BUREAU OF LAND MANAGEMENT

Minutes of the Technical Review Committee

Meeting of 2/18/92

Figure 1.

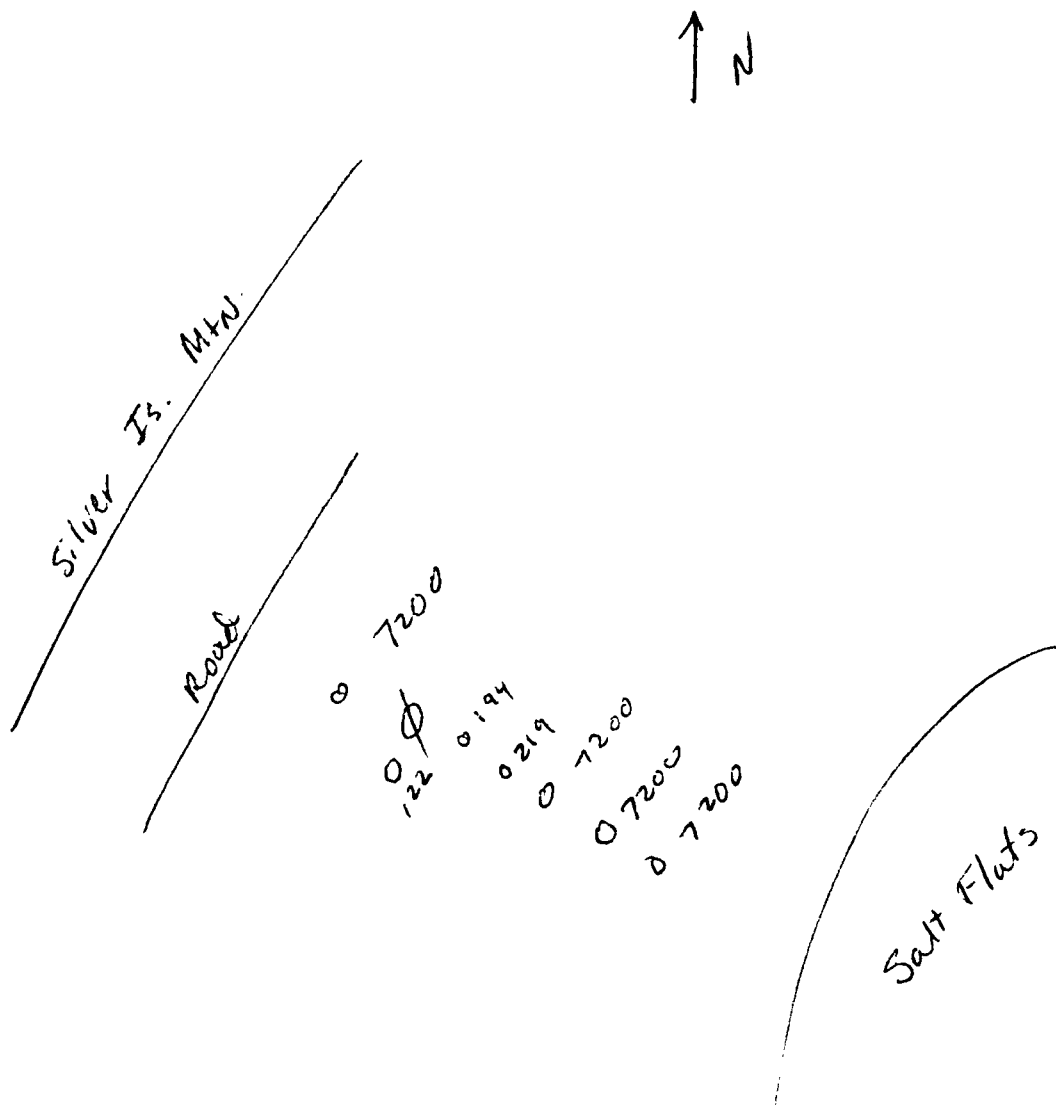
3. JM diagramed the position of the holes on the board. A copy of this diagram is attached as Figure 1.

4. PA asked what difference there was in the elevation of the various holes. JM said that there was very little, but there is a berm from an old ditch between the production well and some of the observation wells. JM also described some of the problems they had with the core drilling crew.

4. PA said that he felt that they had abandoned the idea of having three lines of wells. TN said that he did not think that this was correct. He felt that one line represented the alluvial fan, one represented the ditch and one represented the highway.
